The Bluffs at Darien

SUPPLEMENTAL PUD INFORMATION ADDENDUM

DISCUSSION ITEMS FOR CHANGES TO PROPOSED MASTER PLAN/TEXT

PORCH & SIDEWALK DIAGRAM

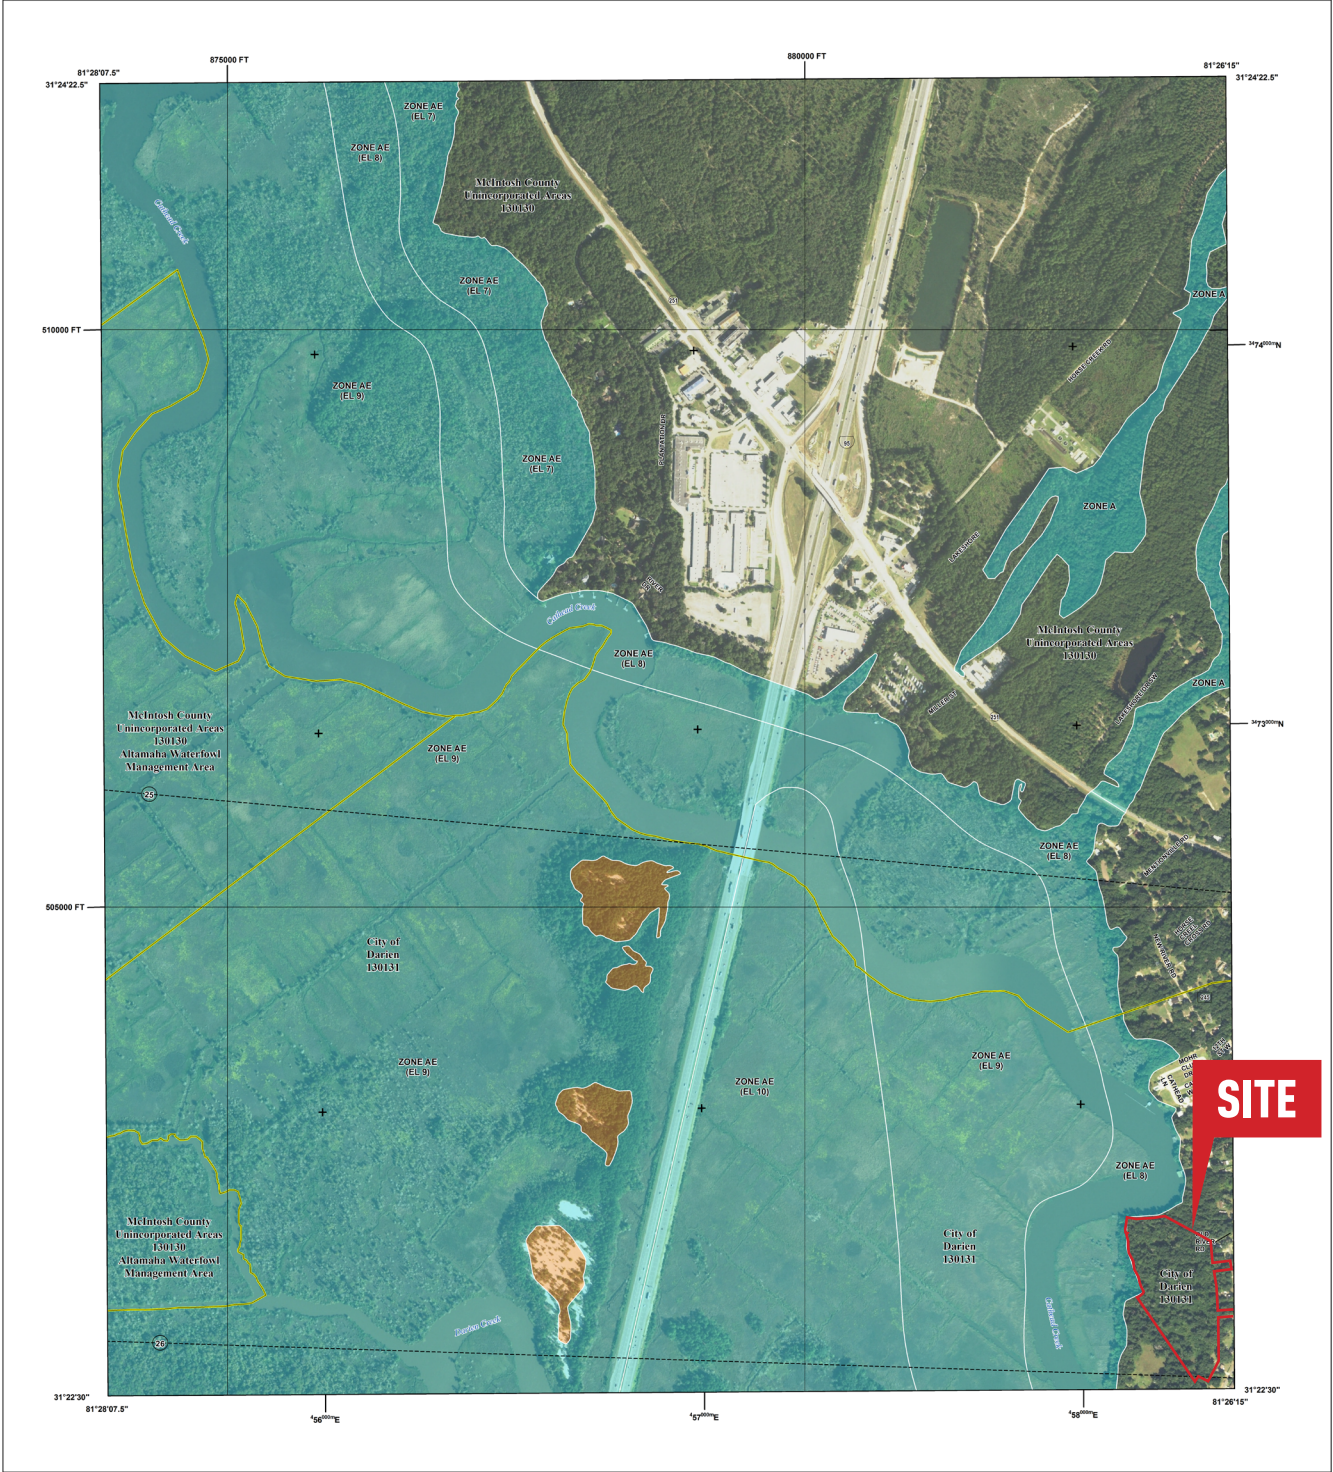
- Does a hard sidewalk touch all parcels?
 - Sidewalk diagram provided; a majority of the sidewalks to be soft surface.
- Is 129 Units a good density
 - 129 units is a balanced density that maximizes open space and tree save. It is also far less than the number of units in the previous approval.

SHEET NAME:
TREE SURVEY

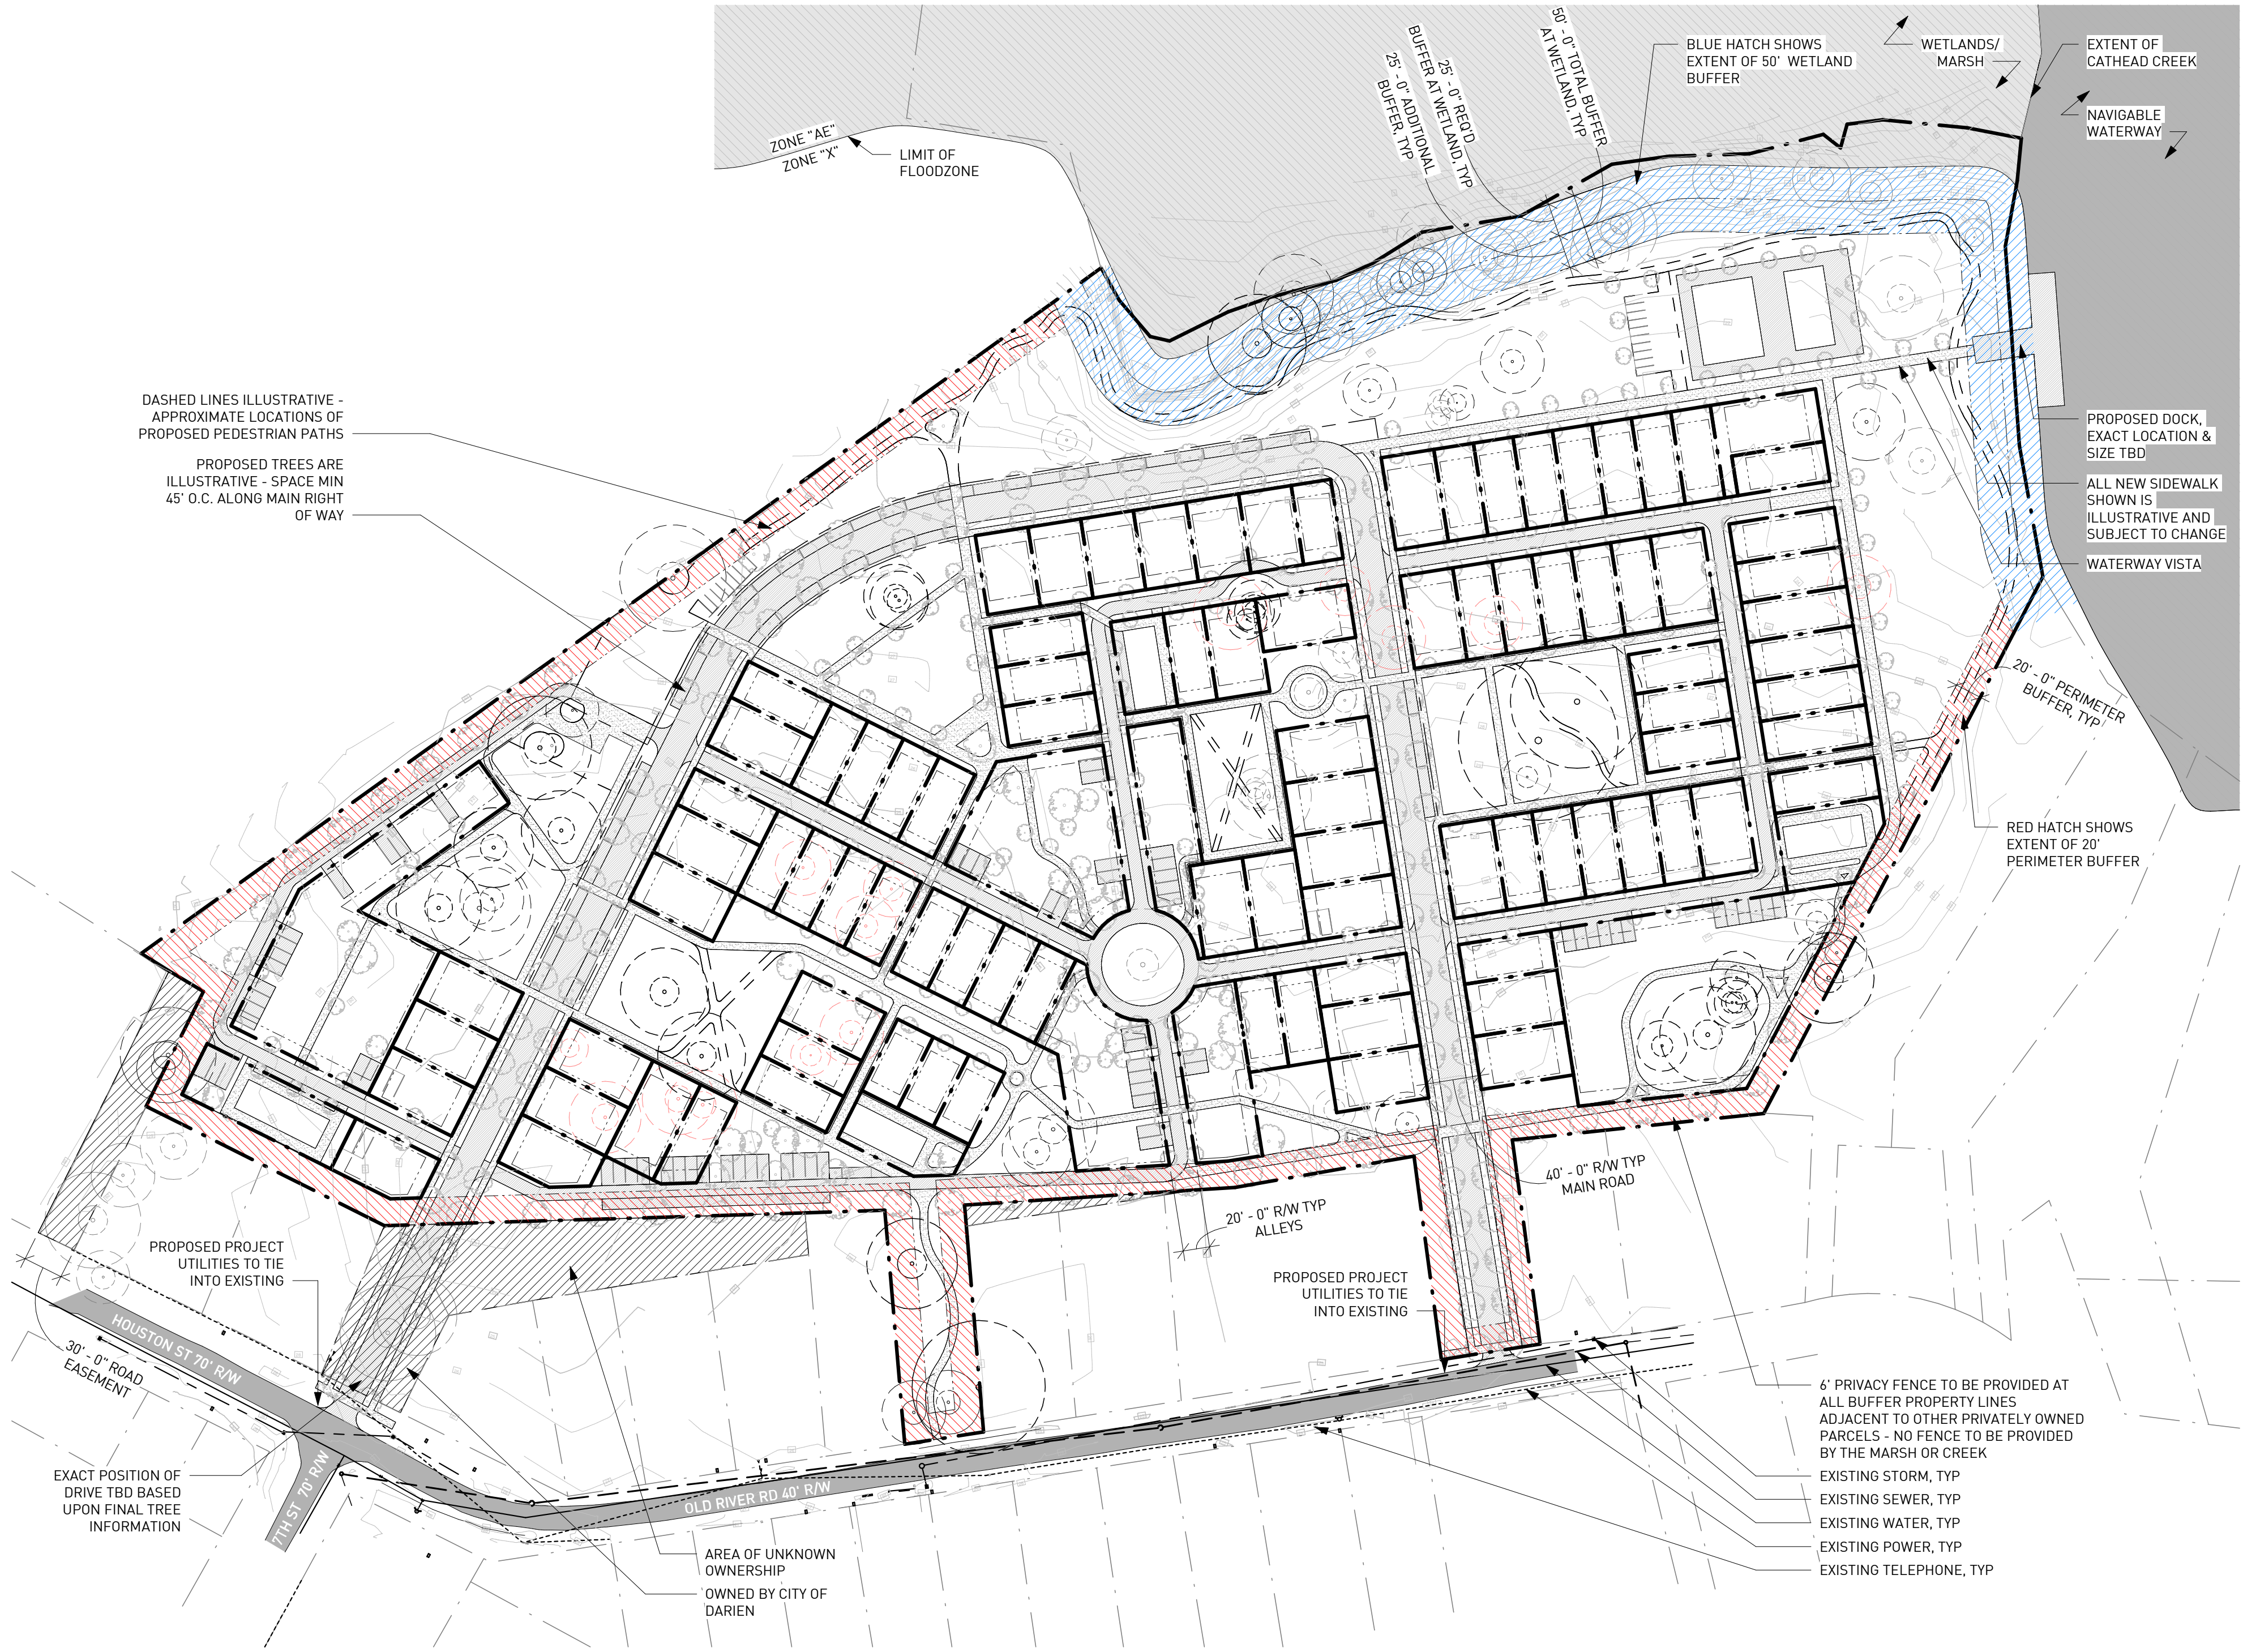
- This will be provided as part of the final SUP submission.
- Since the tree survey has been conducted, require the tree permit be included with masterplan with number of new trees, removed trees, and preserved trees.
